**Ashton Coal Project (DA309-11-2001-I)
Extraction Plan for Longwalls LW205 – LW208**

ATTACHMENT A

Reasons for Approval of Extraction Plan for Longwalls LW205 – LW208

Figure 1: Longwall Layout in Upper Lower Liddell Seam

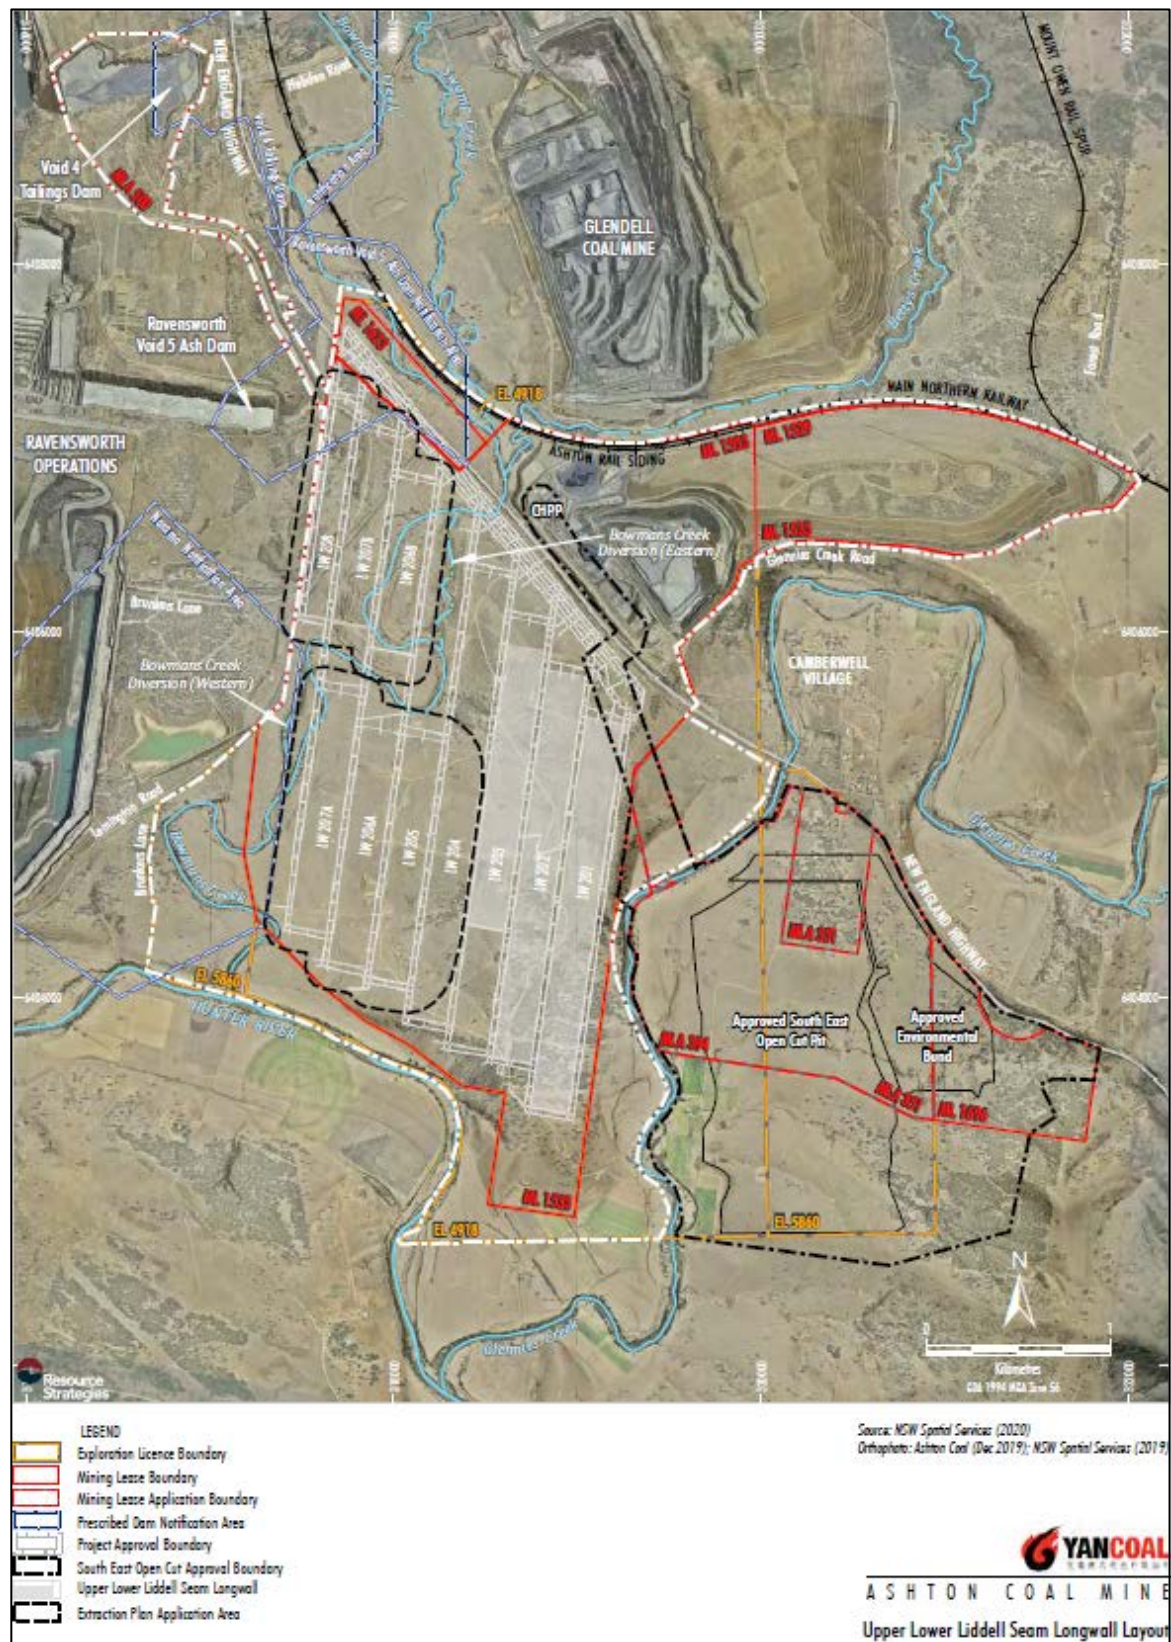
4. The mining domain included in the current EP (**Figure 1**) is split into the northern (LW206B, LW207B, LW208) and southern (LW205, LW206A, LW207A) longwall blocks designed to avoid directly mining under Bowmans Creek.
5. The panel lengths range from 957 m (LW206B) to 1,343 m (LW205) and the void width for majority of longwalls would be 215.4 m except for LW208 where the void width would be 124.0 m. The extraction height would be typically in the range 2.5 m to 2.7 m with an average extraction height of 2.6 m for all longwalls. The minimum chain pillar width would be 24.5 m for majority of longwalls except LW208

8. The EP Area shown in **Figure 1** represents the area likely to be affected by the mining of LW205 to LW208. It is the surface area enclosed by the predicted limit of vertical subsidence from these longwalls and is based on an angle of draw of 26.5° or 0.5 depth to the ULLD seam from the outermost goaf edge of all panels in all seams at the mine.

Figure 2: Built Features within the Extraction Plan Area

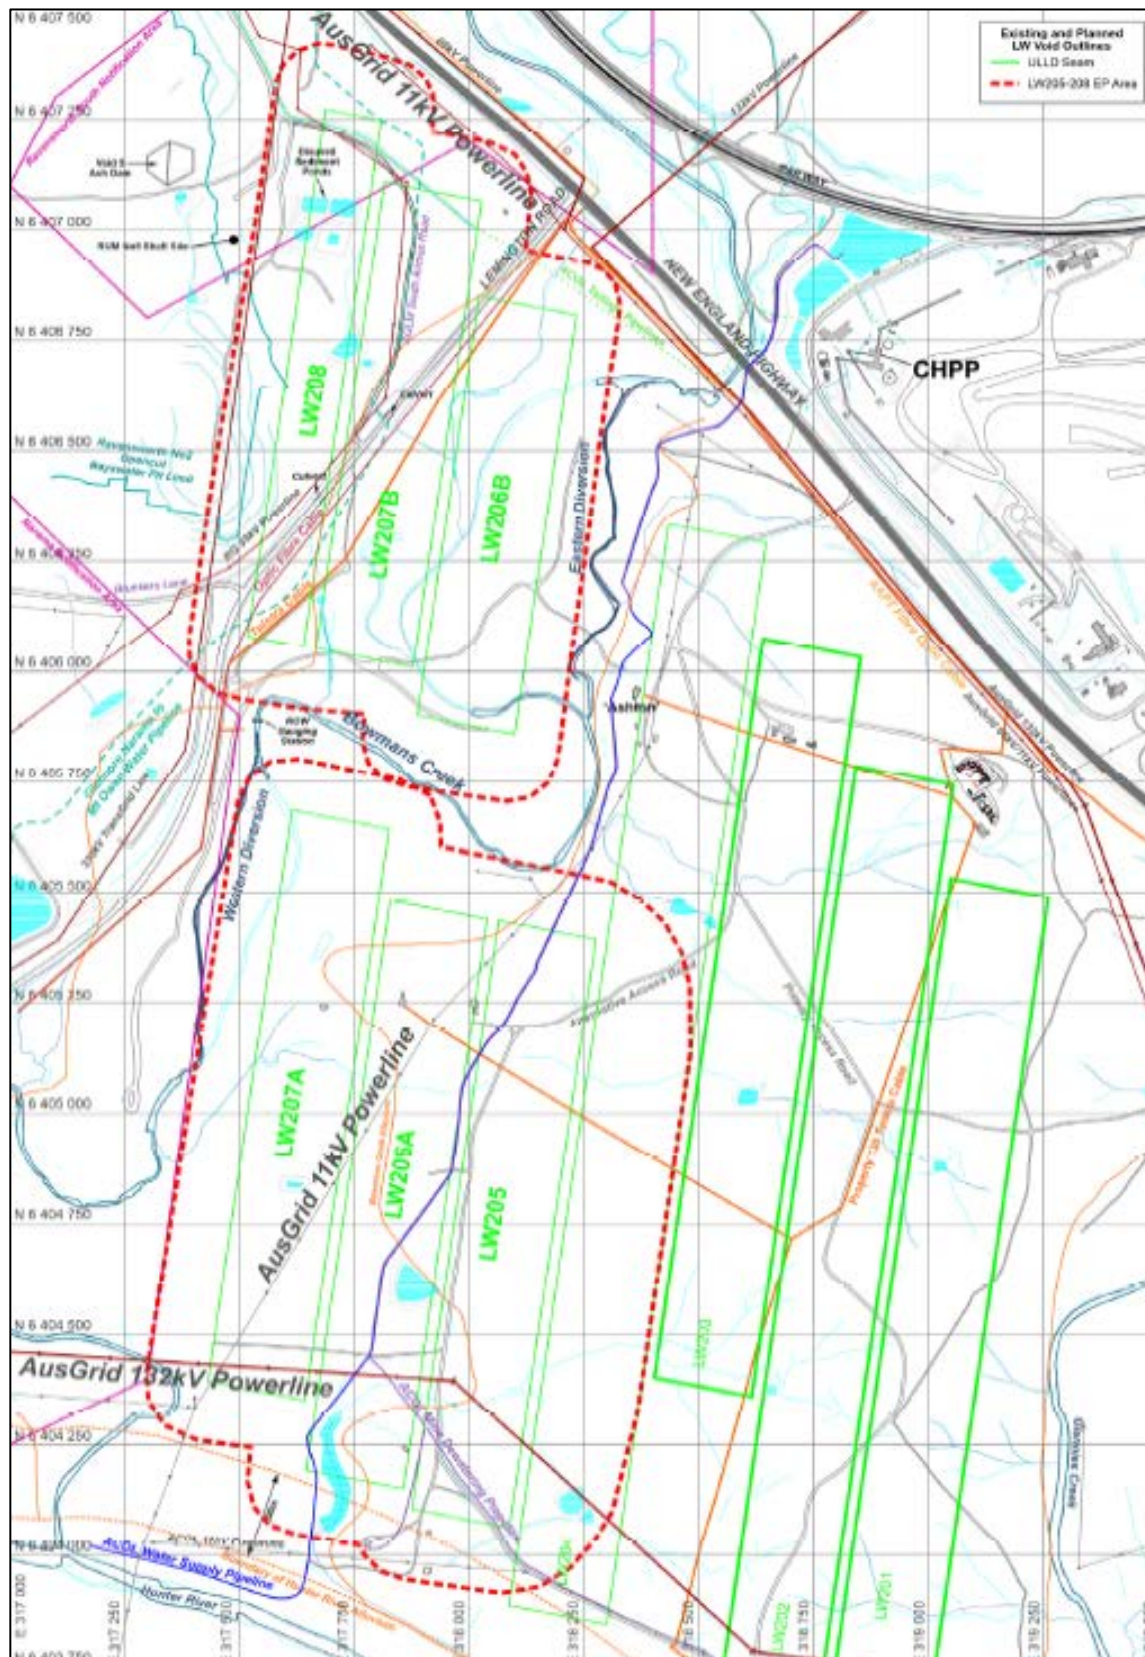
10. Natural and built features shown in **Figure 2** have the potential to be impacted by subsidence from the extraction of LW205 – LW208. These impacts range from a change in the landform, surface cracking, ponding to impacts to built features with the potential to render them unserviceable.
